Federal Aviation
Administration

ZODIAC CH 601 XL AIRPLANE SPECIAL REVIEW TEAM REPORT JANUARY 2010

Figure 1: Comparison of FAA Estimated Loads with 'Zodiac CH 601 XL Stress Analysis and Tests'

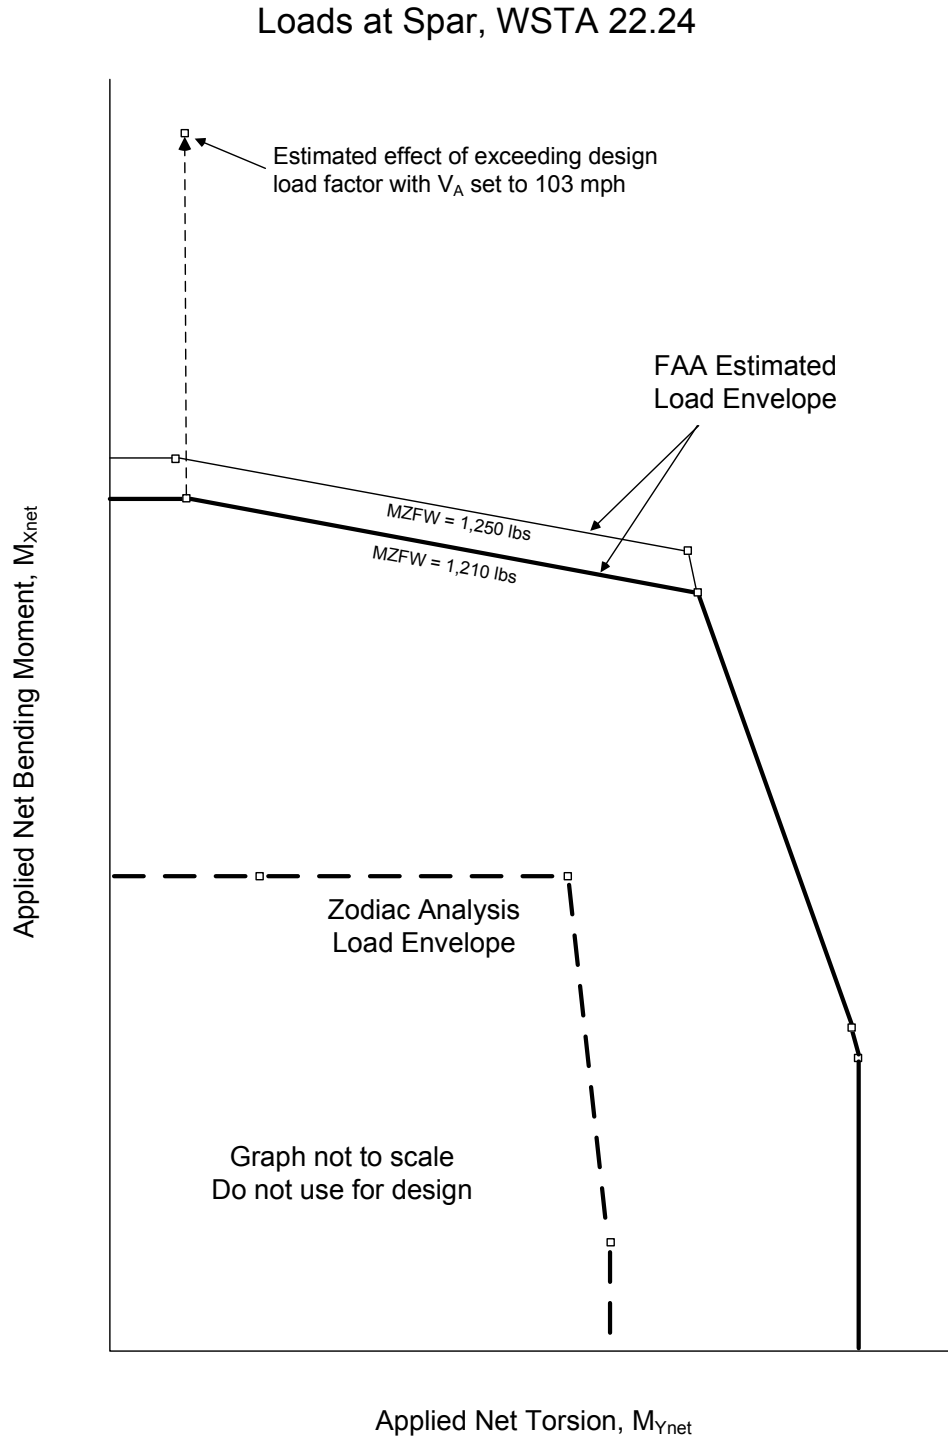
During our review, the FAA developed estimates of the wing bending and torsion loads to determine the relative importance of each of these issues. We estimated the wing loads assuming a minimum value for the MZFW of 1,210 lbs, based on an empty weight of 830 lbs and 380 lbs for the occupants. We also studied the effects of providing an increased MZFW of 1,250 lbs to account for differences in empty weight across the existing fleet, additional installed equipment (e.g. ballistic recovery systems), and for potential structural modifications to the design. Our estimated wing bending and torsion loads are significantly higher than those computed by the manufacturer, as shown in figure 1. (Note: We have removed the actual load values from figures 1 through 4 to protect the manufacturer's proprietary information and data.)

Figure 2: Effect of Pitching Moment Characteristics on Wing Design Loads

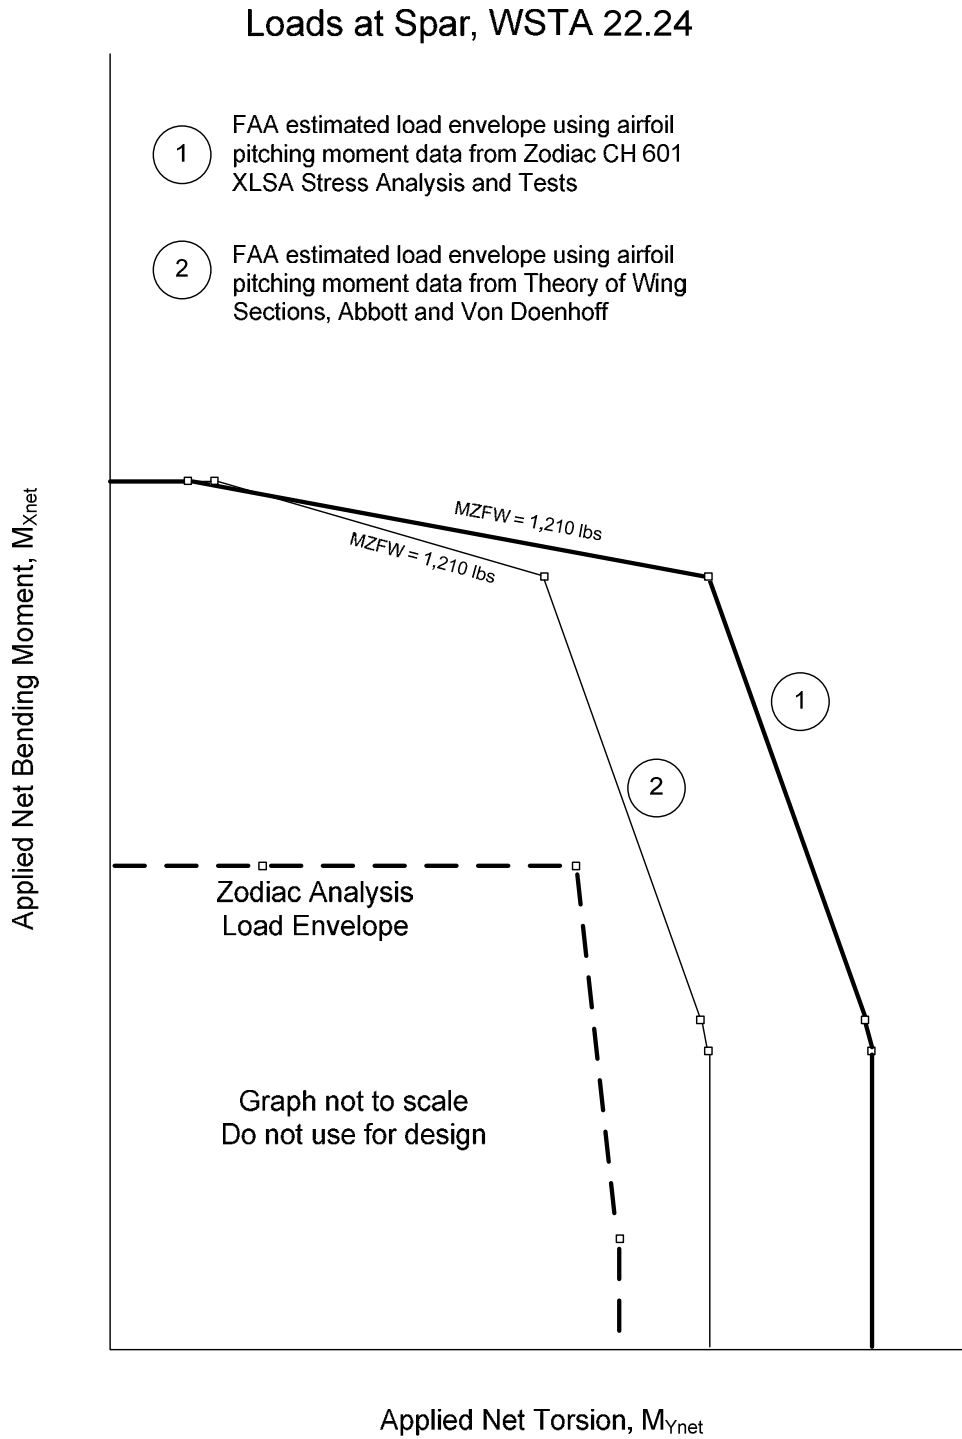
The FAA also studied the importance of the airfoil pitching moment data. As shown in figure 2, the accuracy of this data is critical in determining the torsion loads the manufacturer must use to design the wing. For comparison to the manufacturer's data during the completion of this study, we used wind tunnel test data from the widely used academic publication 'Theory of Wing Sections' by Abbott and Von Doenhoff for an airfoil that appeared to be similar to the one incorporated into the CH 601 XL wing.

Figure 3: Revised Zodiac Analysis and Static Test Wing Design Loads

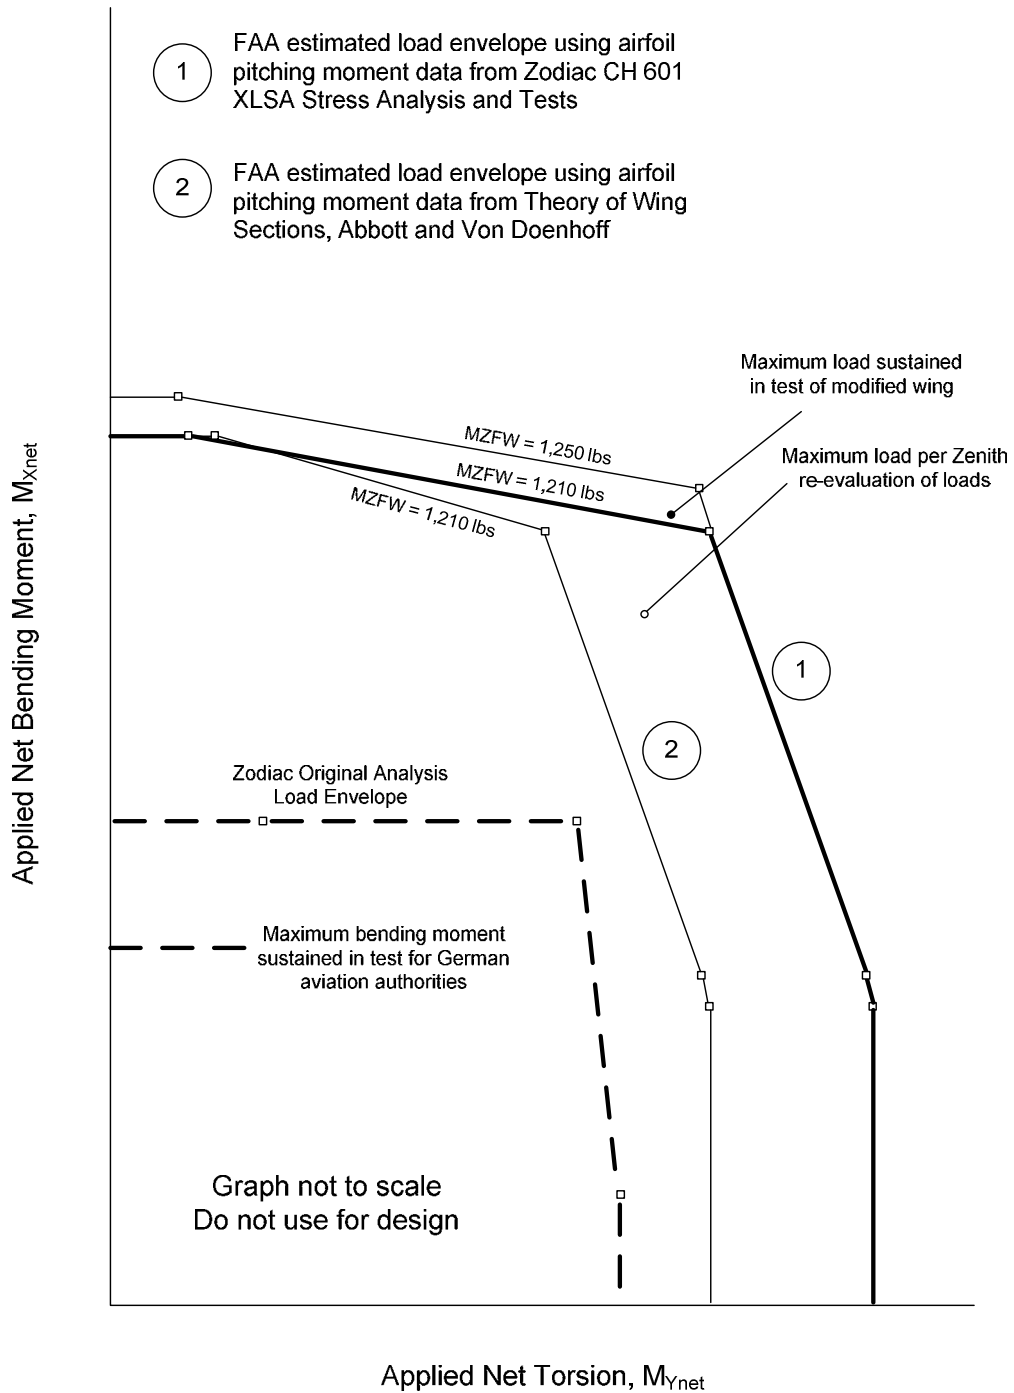
The manufacturer successfully tested the modified wing structure to loads higher than determined in their revised analysis. The wing structure did not fail at the ultimate test loads. However, the wing attachment bolts were bent and the attachment bolt holes were elongated, indicating there was permanent damage to the structure at these loads. We have depicted the loads from the manufacturer's revised analysis and static test in figure 3.

- The manufacturer stopped the static test of the modified structure approximately five percent below the FAA’s load estimates required for ASTM compliance. At the time of this report, the manufacturer was continuing to make modifications to the wing structure and the drawings referenced by the safety directive to provide further improvements. The manufacturer should consider additional structural testing and analysis once a final design is reached to demonstrate the new wing meets the ASTM standards.

Figure 4: History of Zodiac Wing Structural Loads Analysis and Tests

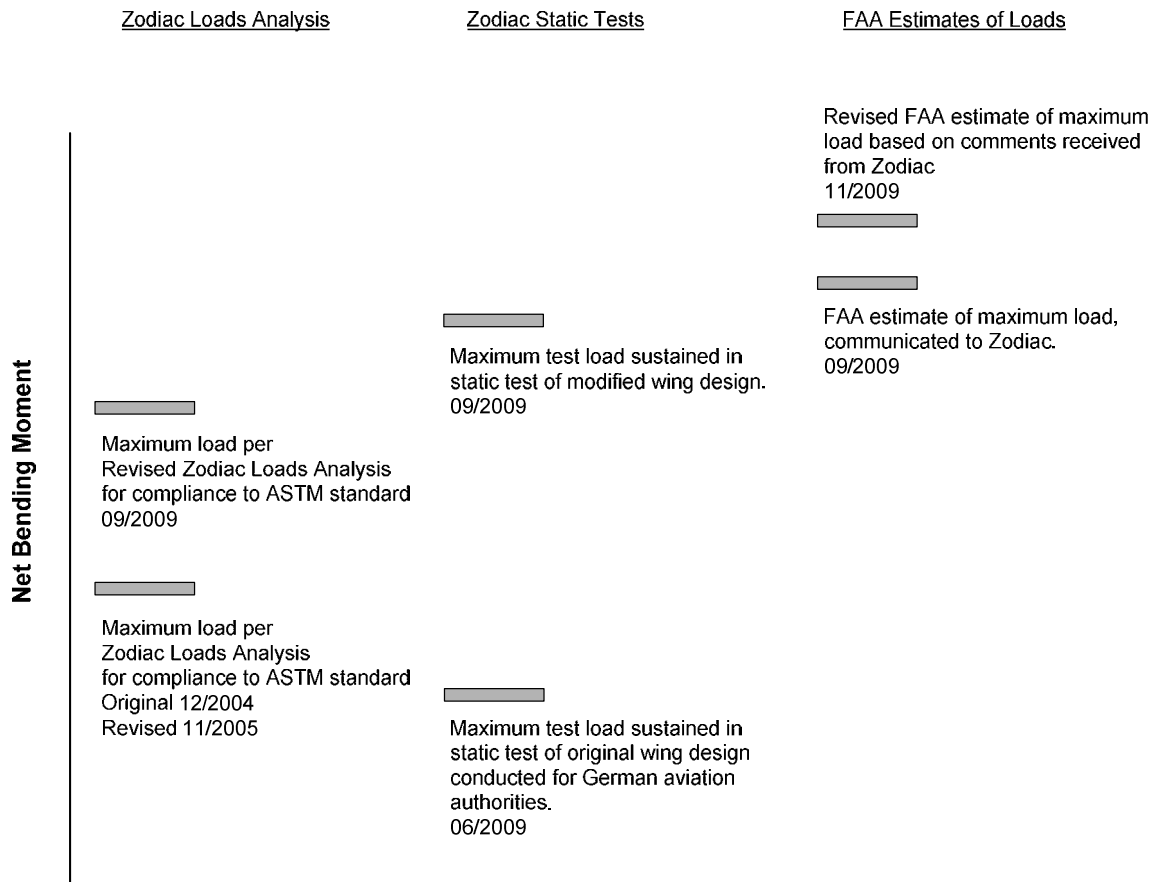
Figure 4 presents a history of the manufacturer's loads analysis and static testing. We provide this information to provide a time line of the manufacturer's structural analysis and testing.

Figure 5: CH 601 XL Stick Force per g Evaluation

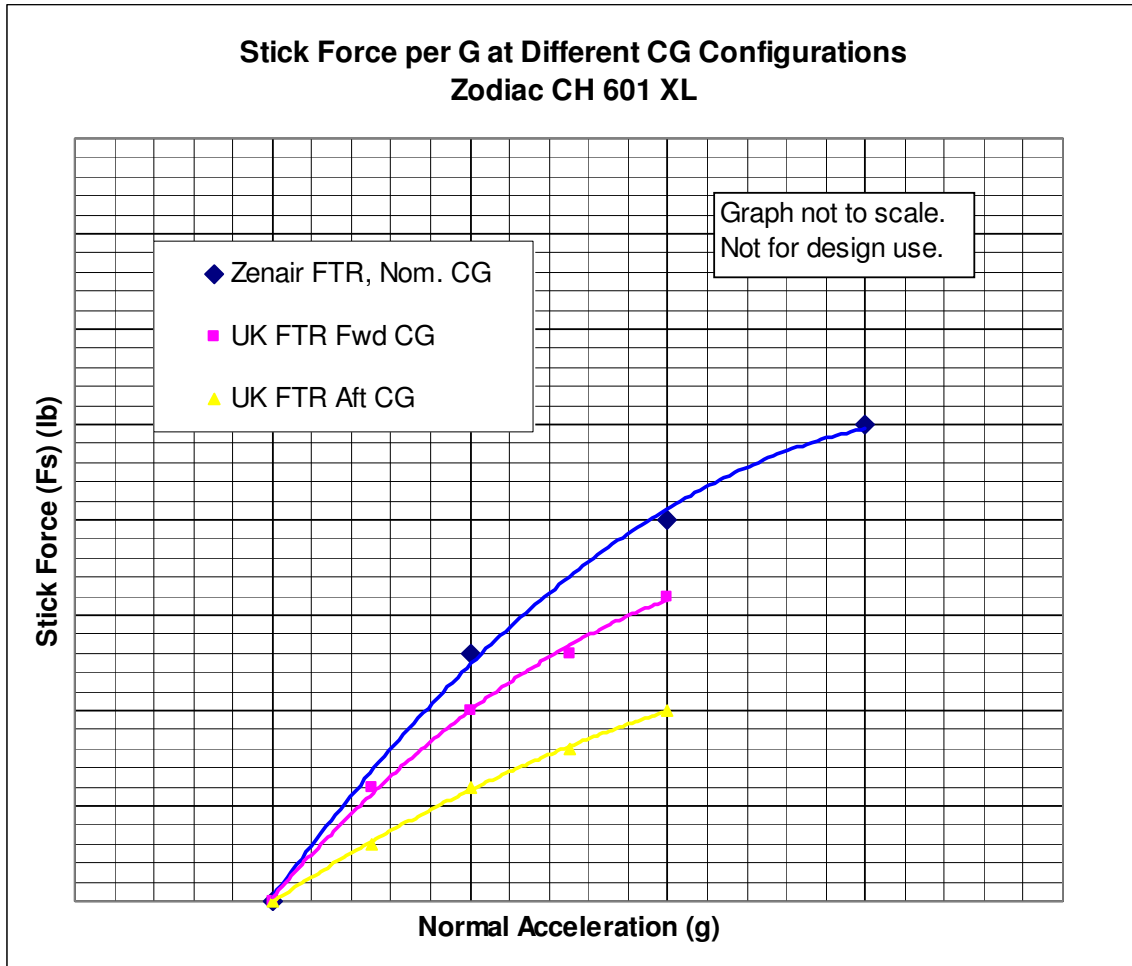
The UK LAA performed flight tests for a flutter mitigation program and provided the results to the FAA. Stick force per g evaluations were conducted at both forward and aft cg. Figure 5 shows the data they obtained appears to be compliant with the ASTM standards as well as with 14 CFR Part 23 § 23.155(c). (Note: We have removed the actual stick force and g load values from figure 5 to protect the manufacturer's proprietary information and data.)

Though not required to do so, it appears their tests followed the guidance provided by AC 23-8B. However, when applying this guidance to aft center of gravity data to match compliance with 14 CFR Part 23 § 23.155(a), Figure 5 shows the stick force at limit load appears to extrapolate to a value slightly less than the 15 pound minimum requirement at limit load. Though the CH 601 XL does not have to comply with 14 CFR Part 23, the data does indicate that stick force gradients may not be acceptable for aircraft that are intentionally or unintentionally flown outside the POH center of gravity limits. This is simply presented for regulatory comparison, as 14 CFR Part 23 § 23.155(a) is not currently reflected in the ASTM standards at any center of gravity configuration.

Figure 6: Standard Day Correction Effects on CH 601 XL Airspeed Calibration

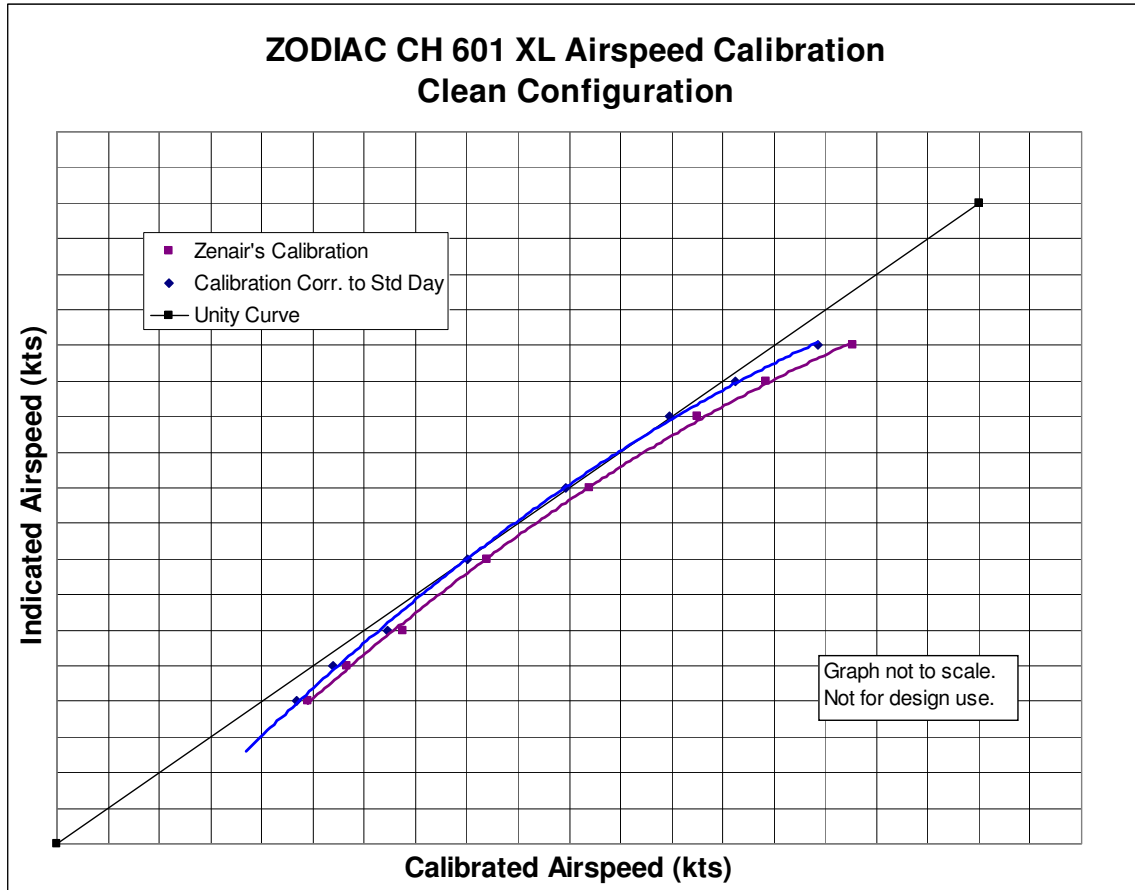
The manufacturer's flight test report was reviewed. It appears the airspeed calibration data presented was only calibrating indicated airspeed to true airspeed. Since this data was collected at a non-standard day temperature of 31°C, and at an altitude other than sea level, a density correction must be applied to the true airspeeds to accurately determine the calibrated airspeeds (compressibility effects are not applicable to light sport airplanes). Figure 6 shows the effect of applying a standard day correction to the airspeed calibration. (Note: We have removed the actual airspeed values from figures 6 through 8 to protect the manufacturer's proprietary information and data.)

Regarding stall speed, the manufacturer's flight test report determined the flaps up stall speed to be 35 knots indicated airspeed (KIAS) (40 mph) which was reported as 43 knots calibrated airspeed (KCAS) (50 mph). In reality, it was 43 knots true airspeed (KTAS) (49 mph), which after correcting to standard day conditions; the stall speed is calculated to be 41 KCAS (47 mph). The manufacturer's Airplane Flight Manual (AFM) reported a 43 knot (49 mph) flaps up stall speed indicating that standard day corrections were not applied to the flight test data.

Figure 7: Zodiac CH 601 XL Airspeed Calibration Comparison

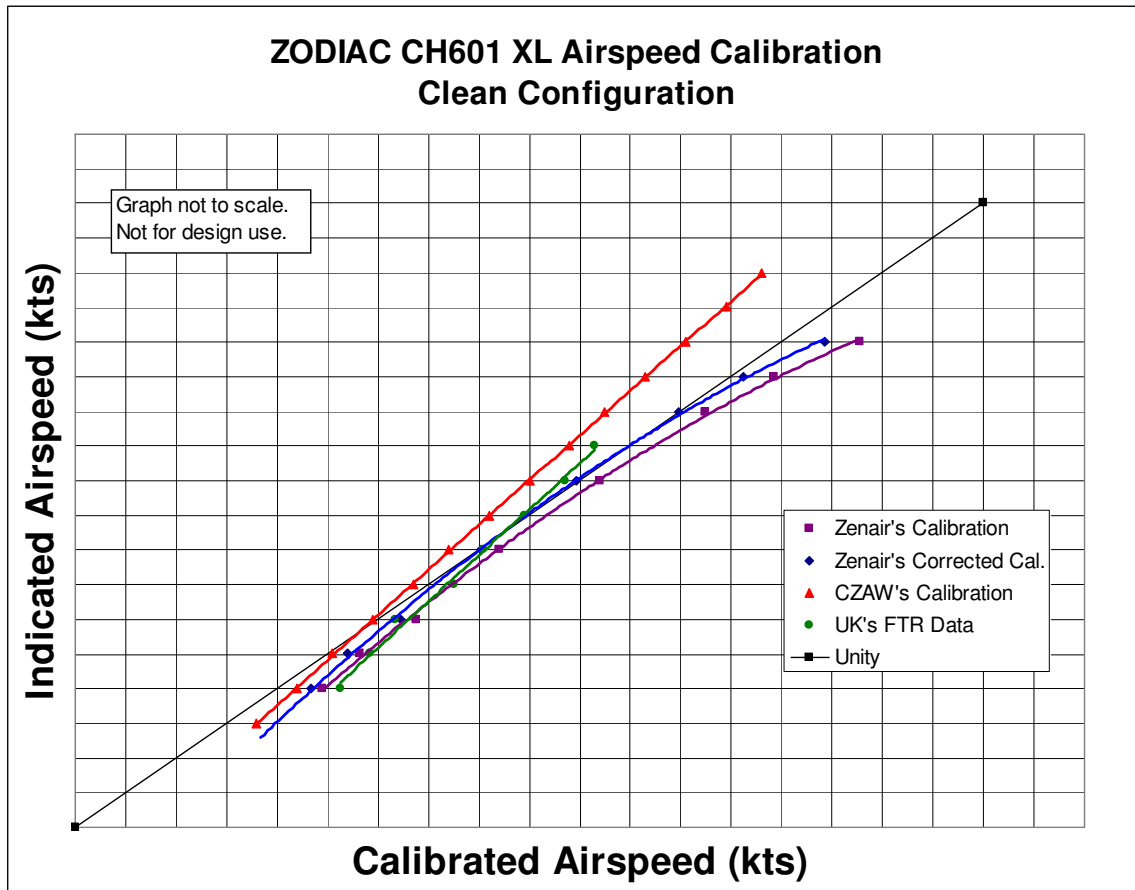
A comparison was made between CZAW and the manufacturer's airspeed calibrations. The calibrations were substantially different in both shape and magnitude. Without the flight test report, it is impossible to say which calibration is correct assuming that both designs are identical. Therefore, the potential to overspeed the aircraft exists. However, as part of the UK LAA flutter mitigation flight test program, an airspeed calibration was conducted and the results were overlaid with those from the manufacturer and CZAW, as seen in Figure 7. (Note: We have removed the actual airspeed values from figures 6 through 8 to protect the manufacturer's proprietary information and data.)

Figure 8: Zodiac Airspeed Calibration Evaluation per 14 CFR Part 23 § 23.1323(b)

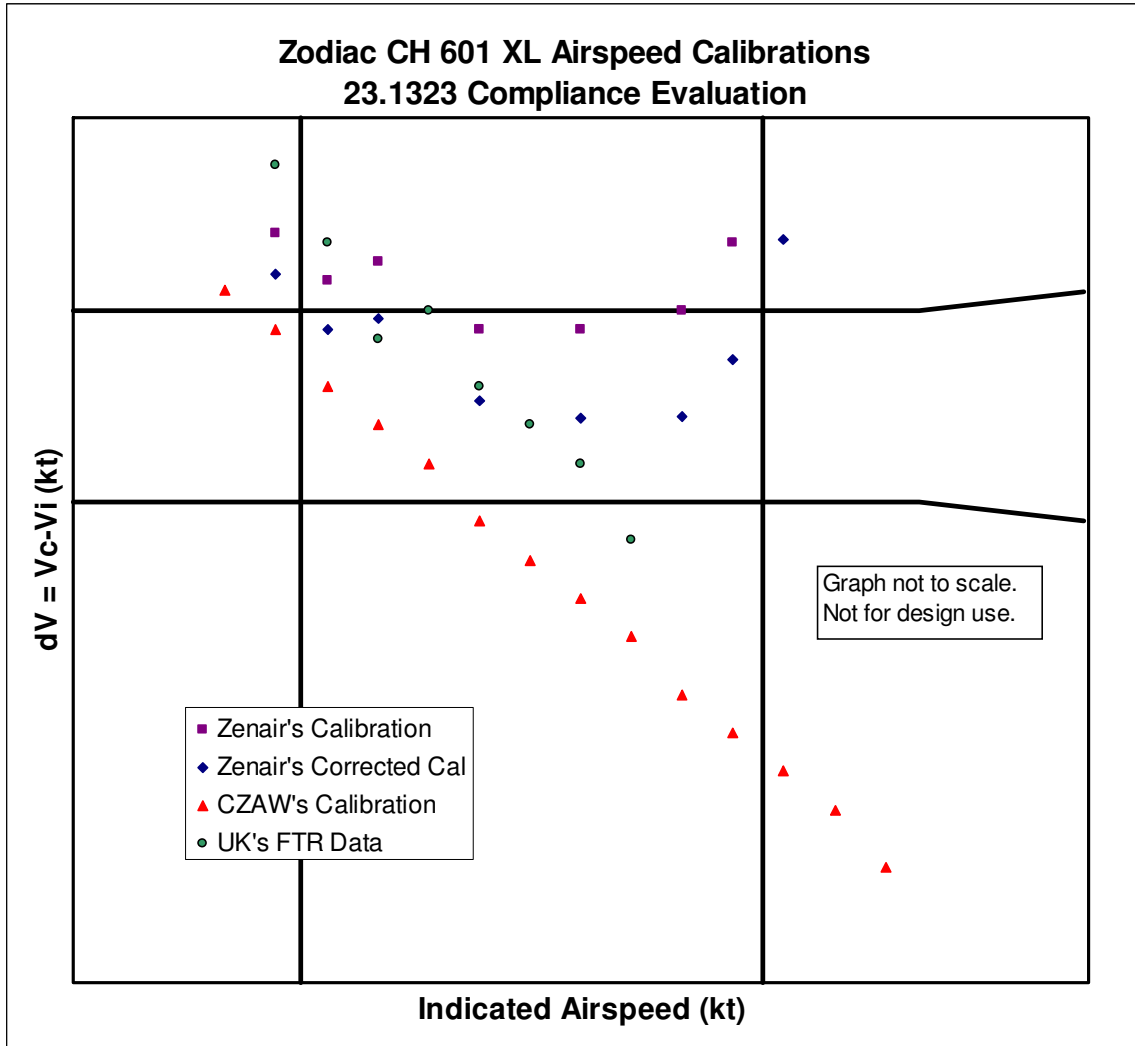
The UK LAA's flight test results are similar in magnitude to the manufacturer's data, but trend with CZAW's data making the comparison inconclusive. Using a different approach to determine the validity of the calibration data, a 14 CFR Part 23 § 23.1323(b) analysis was performed on these data sets and shown graphically in Figure 8. It should be

To evaluate the airspeed error per 14 CFR Part 23 § 23.1323(b), the error dV , must be less than ± 5 knots or 3% bounded by a lower airspeed of $1.3V_{S1}$ to a maximum airspeed of V_{NE} . Using the manufacturer's values, this means that to meet 14 CFR Part 23 § 23.1323(b), all the applicable data needs to fall in the enclosed ± 5 knot rectangle.
